Application for Licence Amendment

Licence Number	L7276/1996/12
Licence Holder	Murrin Murrin Operations Pty Ltd
ACN	076 717 505
Application Number	APP-0027706
Premises	Murrin Murrin Nickel Cobalt Project Mining tenements: L39/62, L39/81, L39/83, L39/136, L39/168, M39/299, M39/300, M39/301, M39/314, M39/322, M39/421, M39/422, M39/423, M39/435, M39/436, M39/424, M39/342, M39/343, M39/420, M39/446, M39/553, M39/562, M39/637, M39/651, M39/686, M39/692, M39/714, M39/715, M39/716, M39/737, M39/820, M39/848 and M39/1066. LAVERTON WA 6440 As defined by Figure 1 attached to the Revised Licence
Date of Report	30 October 2025
Decision	Revised licence granted

Figure 2: Evaporation ponds and monitoring bores

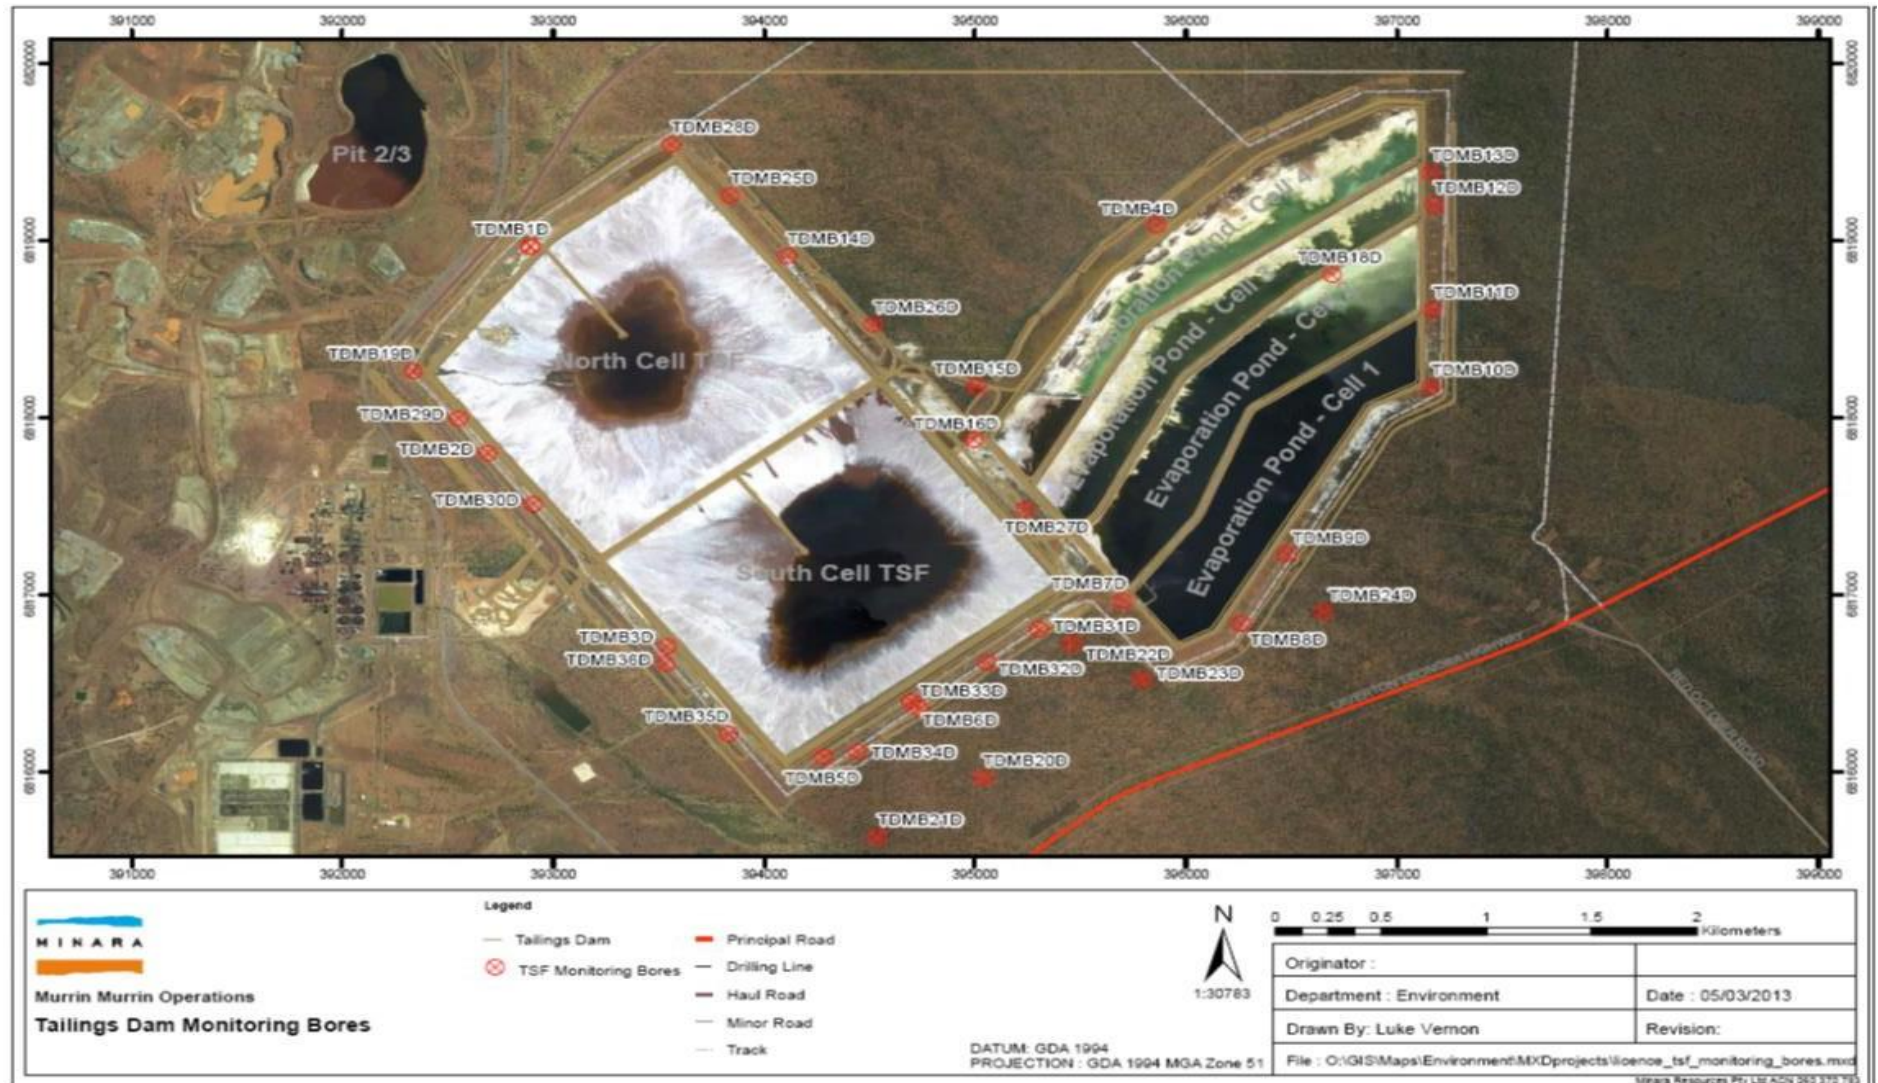
In 2004 the licence holder implemented a Seepage Mitigation Project (Minara Resources 2023) to lower the rising groundwater mound identified beneath the paddock TSF and evaporation ponds (Figure 2). The Seepage Mitigation Project goal was to also reduce the migration of contaminants seeping from the paddock TSF and evaporation ponds to downstream areas. To achieve these goals and assess the effectiveness of the Seepage Mitigation Project a Seepage Management Plan (SMP) was developed. As part of this SMP seepage recovery infrastructure was installed. As of 23 April 2025, there are currently 100 seepage recovery equipped bores and four seepage interception trenches around the perimeter of the paddock TSF and evaporation ponds (Minara Resources 2025).

Historical TDS and nickel concentrations recorded in monitoring bores associated with the evaporation ponds are presented in Table 4 and Table 5 respectively. Results indicate that generally TDS concentrations recorded around the evaporation ponds is brackish (1,000 – 10,000 mg/L). Saline (10,000 – 35,000 mg/L) to hypersaline results (>35,000 mg/L) have been recorded within TDMB4D, TDMB18D and TDMB27D which are located to the north, between cell 2 and cell 3 ponds and to the west of the evaporation ponds respectively (Figure 2).

Figure 7: Change in standing water levels from 2020-2021 annual period to 2024-2025 annual period

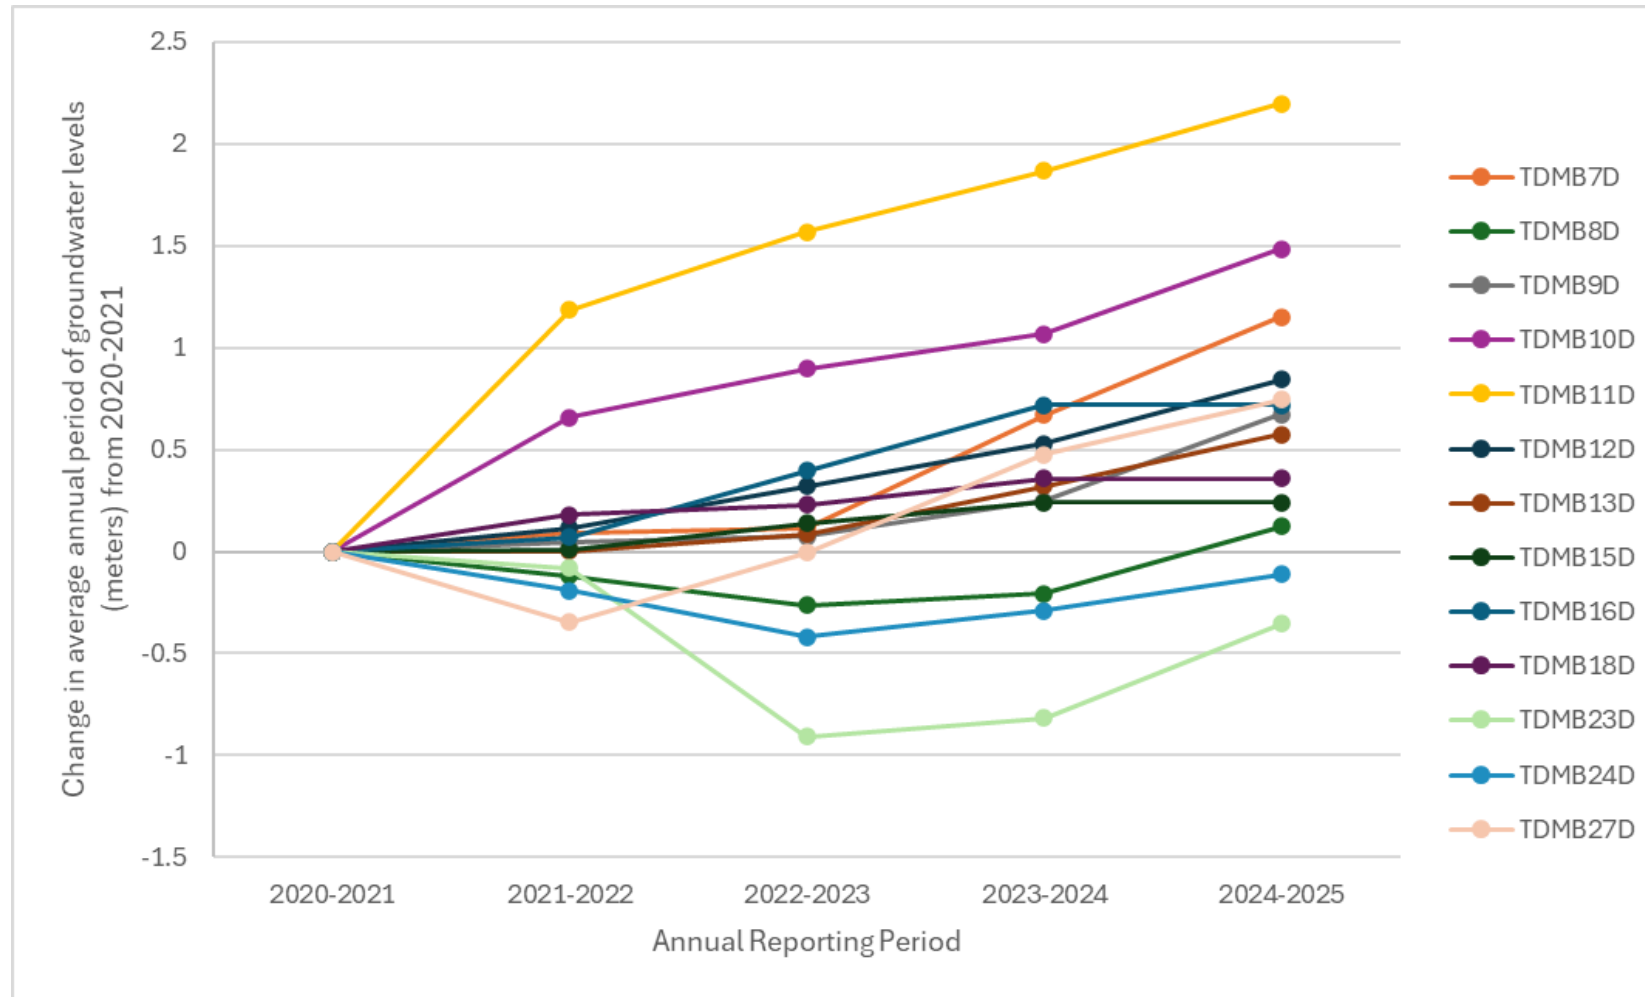
Recent standing water level (SWL) measurements from groundwater monitoring bores surrounding the evaporation ponds indicate that groundwater levels have either plateaued or are continuing to rise. Figure 7 illustrates the change in groundwater levels over time, comparing data from the 2020–2021 annual reporting period to the 2024–2025 period. Average groundwater levels were calculated for each reporting year (1 May to 30 April) and plotted as deviations from the 2020–2021 baseline. All monitoring bores in the vicinity of the evaporation ponds show an upward trend in groundwater levels, with the exception of TDMB24D and TDMB27D, which did not follow this pattern. Figure 8 presents historical groundwater data dating back to 2001, highlighting that current groundwater levels are significantly elevated compared to baseline conditions.

Figure 8: Historical standing water levels from 2001 to 2024 in monitoring bores surrounding the evaporation ponds

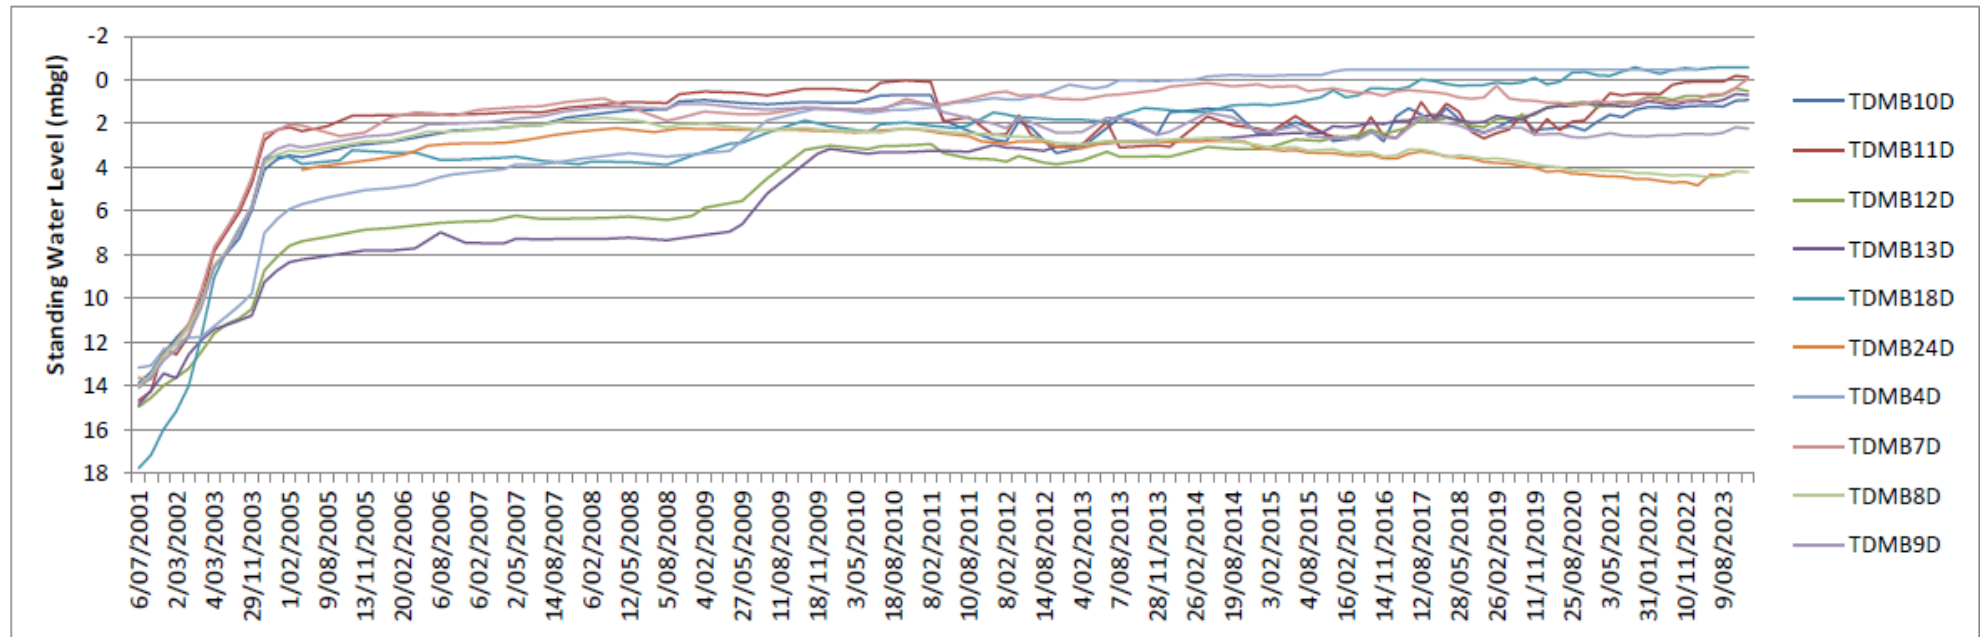
Artesian conditions, where groundwater flows freely from the top of bore casings without the need for pumping, have been observed in areas surrounding the evaporation ponds. These conditions can significantly impact local vegetation and lead to salt crust formation on the surface following water evaporation (Saprolite, 2025). According to the latest quarterly report submitted to the department for the Paddock Tailings Storage Facility Seepage Mitigation Project (Q1 2025), groundwater levels in five monitoring bores were recorded above ground level. These bores are located in the northern, southeastern, and western sections of the evaporation ponds. It is currently assumed that seven groundwater monitoring bores are exhibiting artesian conditions. This assumption is based on historical measurements from bore TDMB4D, which recorded a standing water level (SWL) of 0.47 meters above ground level in February 2023, and bore TDMB15, which recorded an SWL of 0.53 meters above ground level in May 2024.
